UNITED STATES PATENT AND TRADEMARK OFFICE

APPLICATION NO.	FILING DATE	FIRST NAMED INVENTOR	ATTORNEY DOCKET NO.	CONFIRMATION NO.
10/758,012	01/16/2004	Tomoyuki Kojima	0051-0217P	5749

Office Action Summary	Application No. 10/758,012	Applicant(s) KOJIMA ET AL.	
	Examiner WILLIAM MCCALISTER	Art Unit 3753

DETAILED ACTION

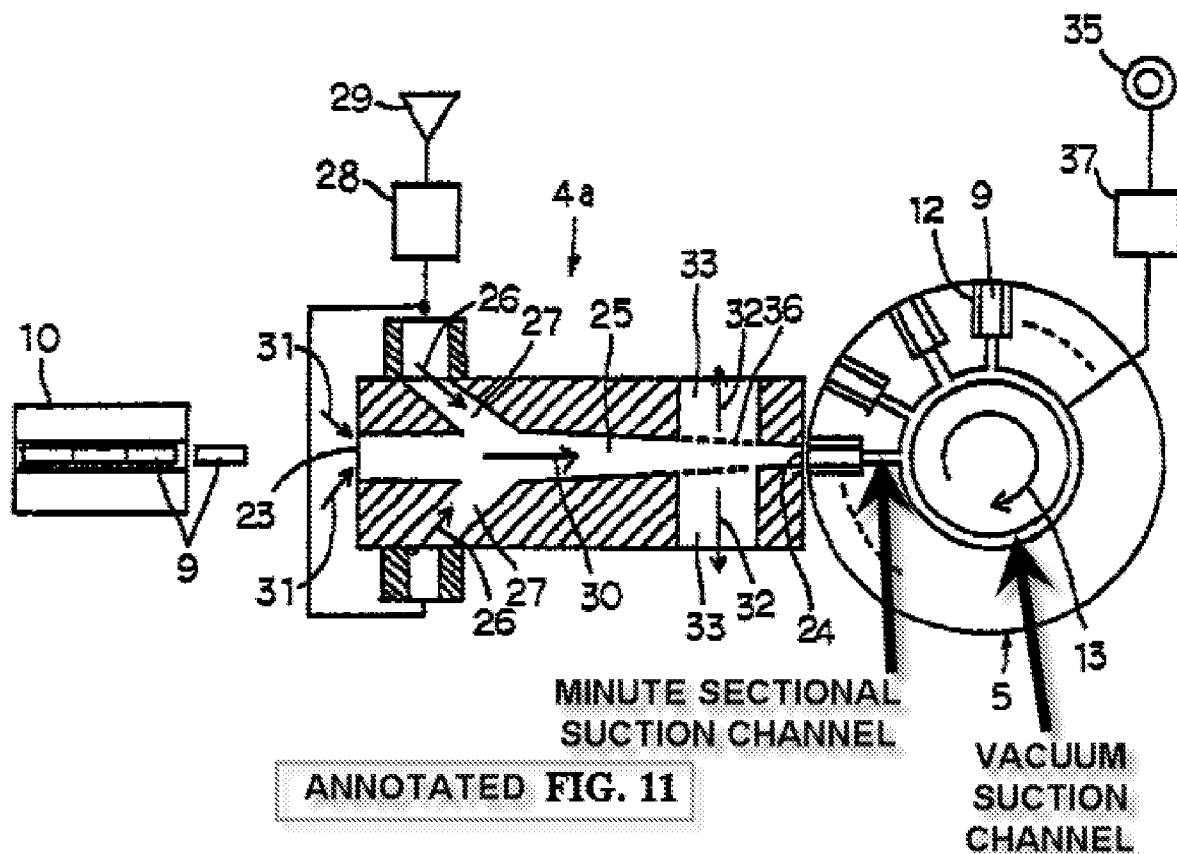
- a vacuum suction channel (see annotated FIG 7 below),

- each work receiving opening being connected to the vacuum suction channel, through a minute sectional suction channel provided on the conveyor

table (see annotated FIG 11), the sectional area of the minute sectional channel being smaller than that of the vacuum suction channel (as seen in FIG 11, the minute sectional suction channels are smaller (shorter) than the vacuum suction channel).

To more accurately control Arishiro's vacuum suction system using closed-loop feedback, it would have been obvious to one of ordinary skill in the art at the time of invention to supplement Arishiro's vacuum suction system with a vacuum level adjustment mechanism, as taught by Mori.
